City of Sandy

Planning Commission Meeting

Meeting Date: Monday, April 8, 2019

3. PUBLIC HEARING – Type III Subdivision for Jacoby Heights Subdivision (18-025 SUB/VAR/TREE/FSH/INT) Chairman Crosby opened the public hearing on File No. 18-025 SUB/VAR/TREE/FSH/INT (Jacoby Heights Subdivision) at 7:01 p.m. Crosby noted that this is a quasi-judicial public hearing. He called for any abstentions, conflicts of interest, ex-parte contact, challenges to the jurisdiction of the Planning Commission, or any challenges to any individual member of the Planning Commission.

SHEET 1 OF 10

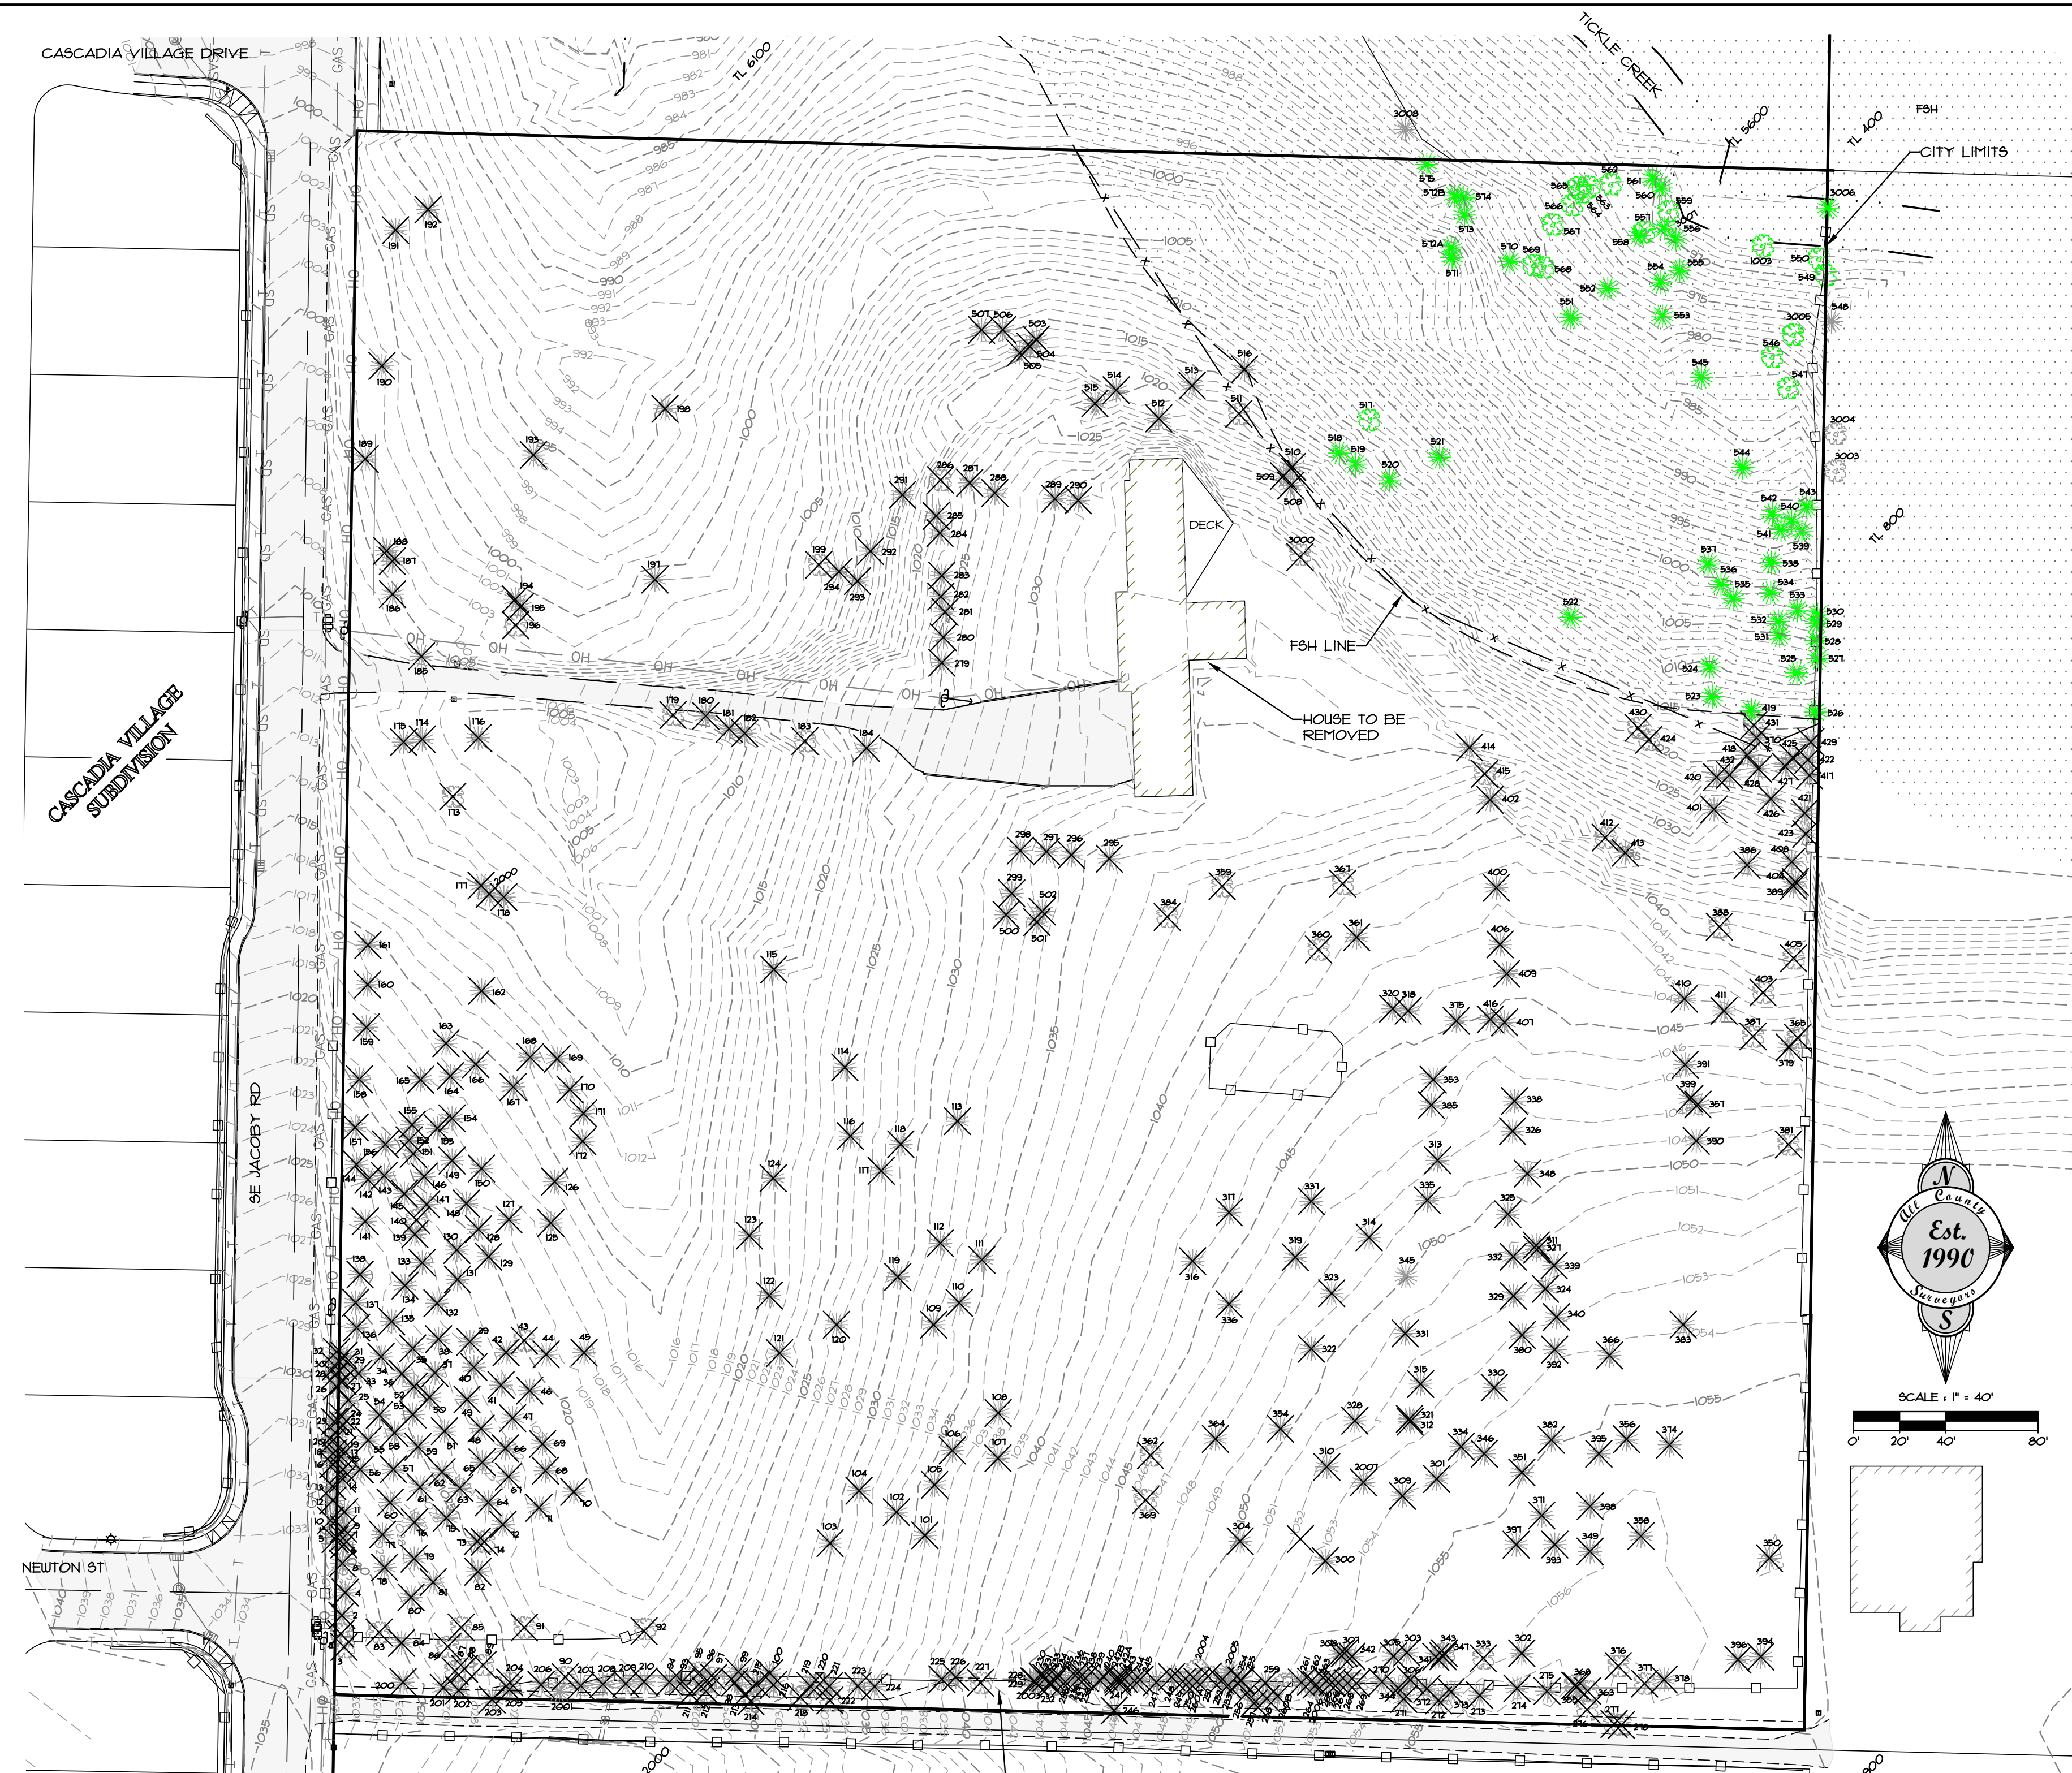
RESPONSE: *The Preliminary Plat (Exhibit C, Sheet 1) does not show the correct measurement of 50 feet of tangent alignment at the intersection of Jacoby Road and Newton Street as required by 17.84.50(H.5.b). The applicant measured the 50 feet of tangent alignment from the centerline of Jacoby Road rather than from the curb line extended. **The applicant shall revise the alignment of Newton Street to conform to the 50 feet of tangent alignment standard.***

RESPONSE: *Garages are required to be at least 22 feet setback from the front property line to meet setback requirements in the SFR zoning district. The Preliminary Plat (Exhibit C, Sheet 1) details a typical 22 foot garage setback.*

BY		SHEET	5
REVISION		OF	10
DATE		DESIGNED:	CTH
		DRAWN:	CTH
		CHECKED:	RLT
		APPROVED:	RLT

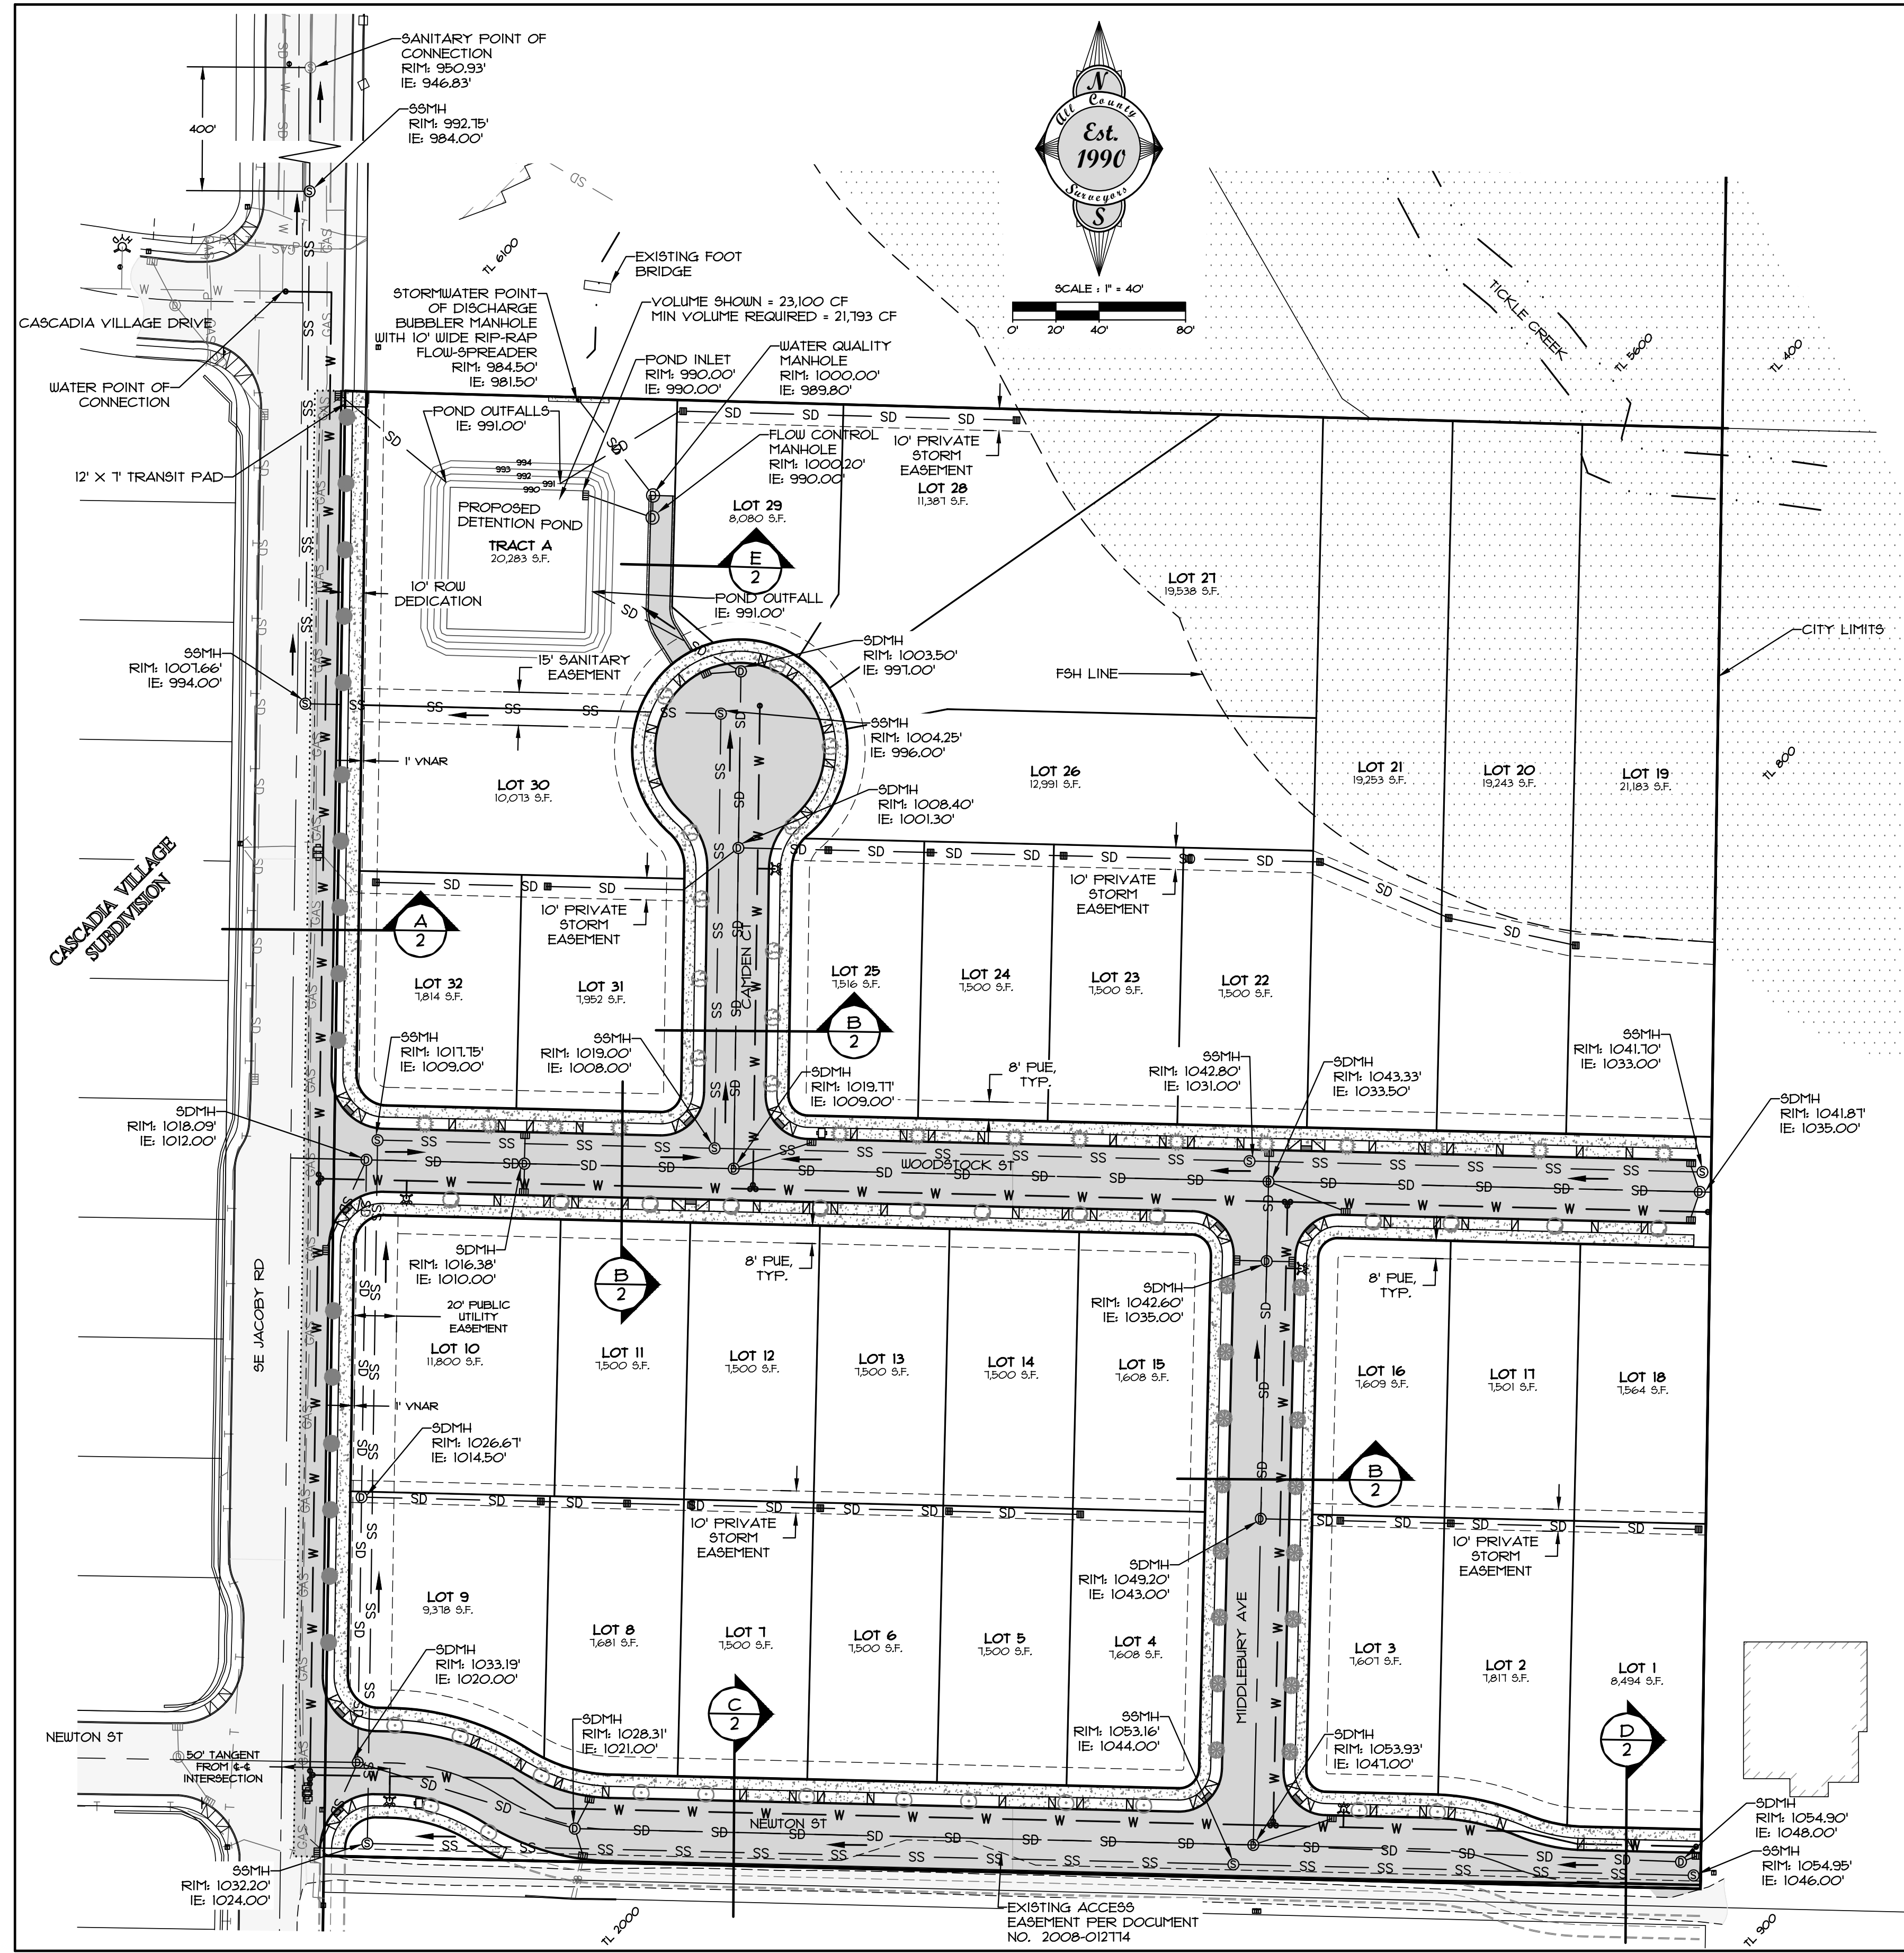
property boundary. The Preliminary Street and Utility Plan (Exhibit C, Sheet 5) shows the street improvements on Woodstock Street ending approximately 7 feet from the development site boundary. Section 17.84.50(E) requires extension of street improvements “to the edge of adjacent properties.” **The applicant shall extend the street improvements on Woodstock Street to the east line of the development site and obtain slope easements or construct retaining walls as necessary to comply with this section of the development code.** At the February 25, 2019 Planning Commission hearing, the applicant’s representative indicated the applicant doesn’t have an easement from the neighbor and obtaining one could be burdensome. In response, the Public Works Director and City Engineer note: “The condition gives the applicant the option of a retaining wall or an easement to allow extension of the street. The condition doesn’t require neighbor participation nor is it contingent on same. Based on the grading plan the wall would be a fill wall, less about 2 feet in height. This is neither problematic or [sic] expensive. The bottom of the wall would be above any required utilities (which are shown extending all the way to the property line. The typical method when extending a street with a fill wall is to remove the top course or two and leave the rest of the wall in place and bury it when the street is extended, no removal required. Even if removal would be required it would be no more expensive than removing the soil (whether fill or cut) at the end of the street when extended.” The Public Works Director and City Engineer recommend the condition remain as written.

The preliminary street and utility plan (Exhibit C, Sheet 5) shows the sidewalk and planter strip improvements on the south side of Newton Street across from Lot 9 ending before the development site boundary. Section 17.84.50(E) requires extension of street improvements “to the edge of adjacent properties.” ***The applicant shall extend the street improvements on Newton Street across from Lot 9 to the south line of the development site and obtain slope easements or construct retaining walls as necessary to comply with this section of the development code. Improvements shall include extension of the Newton Street sidewalk and planter strip, one additional street tree, and landscaping the additional 17.70 feet of right-of-way dedication at the southeast corner of Newton Street and Jacoby Road. The applicant shall submit a landscaping plan for the 17.70 feet of ROW dedication for staff review and approval.***

RESPONSE: *The applicant’s Preliminary Street and Utility Plan (Exhibit C, Sheet 5) depicts the location and type of proposed public utilities including water, sanitary sewer and stormwater. **All public utility installations shall conform to the City’s facilities master plans. Staff recommends the applicant revise the utility plan to include broadband fiber locations as detailed by the SandyNet Manager. Per the City Engineer (Exhibit L), all public sanitary sewer and waterline mains shall be a minimum of 8 inches in diameter and all stormwater drains shall be a minimum of 12 inches in diameter and shall be extended to the plat boundaries where practical to provide future connections to adjoining properties. No building permits will be issued until all public utilities including sanitary sewer are available to serve the development. The applicant shall pay plan review, inspection, and permit fees as determined by the Public Works Director. The utility improvements proposal and requirements for the Jacoby Heights subdivision are further detailed in Sections 17.100.230, 17.100.240, and 17.100.250 below.***
